**CITY OF SNELLVILLE  
DEPARTMENT OF PLANNING & DEVELOPMENT  
MAYOR AND COUNCIL**

**CASE SUMMARY**

**CASE NUMBER:** #CUP 18-03

**DEVELOPMENT/PROJECT:** O'Reilly Auto Parts Store

The proposed site plan, submitted by the applicant.

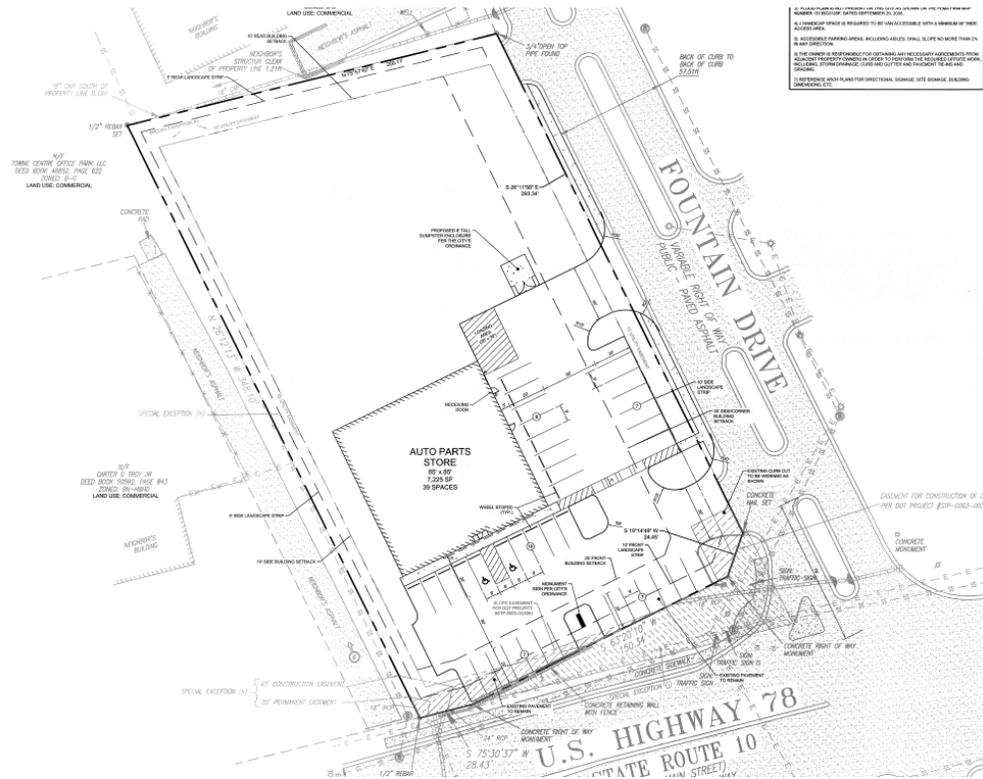
There are two neighboring commercial parcels, to the north and to the west. The concept plan shows the removal of most of the impervious surface on the rear of the property. As a result, access to the parcel to the north along Fountain Drive would not be practical due to the distance created. The neighboring parcel to the west is a 25± foot wide strip of asphalt that connects the bulk of the property to W. Main Street, though there is no curb cut. Requiring access to this parcel would be impractical, and would require guests to then cross into the following parcel to exit the property. Though not requested by the applicant, this variance is reasonable.

The concept plan shows the front parking lot, beginning at and running parallel to the front property line with a concrete retaining wall and fence beginning midway and running west to the western front corner of the property. Although there is a large sodded area located between the front parking row/retaining wall and public sidewalk, this area is within the public right-of-way and not part of the front landscape strip.

The concept plan accurately depicts the location of the 10 foot required front landscape strip. Shifting or reducing the building footprint will allow implementation of the front landscape strip for the planning of trees and shrubbery which will help to create a more aesthetically pleasing visual quality from the W. Main Street perspective. The Planning Department recommends denial of this request.

The applicant is requesting waiver from the requirement to install a pedestrian sidewalk along Fountain Drive due to the lack of an existing sidewalk along Fountain Drive for them to tie into. The Planning Department does not support this request as there are no physical features on the corner property that present a hardship that would make installation not feasible.

The concept plan shows 24 parking spaces in front of the building and 15 parking spaces on the corner side of the building, with no parking in the side or rear of the building. As shown on the concept plan, there are a total of 39 parking spaces, requiring no more than 8 spaces be located in front of the building and no more than 8 spaces be located to the side of the building, with the remaining 23 spaces to be located behind the building. Relocating the building closer to the front and corner side would achieve greater compliance with this requirement.

The concept plan also shows the addition of a full-access curb cut on Fountain Drive. Currently there are two existing curb cuts at each end of the property along Fountain Drive, with the northern curb cut remaining for possible future development. The southernmost existing curb cut may need to be relocated so that it sits back at least 125 feet from the Fountain Drive and W. Main Street intersection.

- a) 10 feet wide front landscape strip.
- b) Concrete sidewalk along Fountain Drive.
- c) A slightly larger building footprint (now 7,639 sq. ft.) for exemption of the requirement that no more than twenty-percent of the parking may be located in front of the building or to the sides or the building.
- d) Conversion of the existing southernmost full-access drive on Fountain Drive to a right-in/right-out drive.
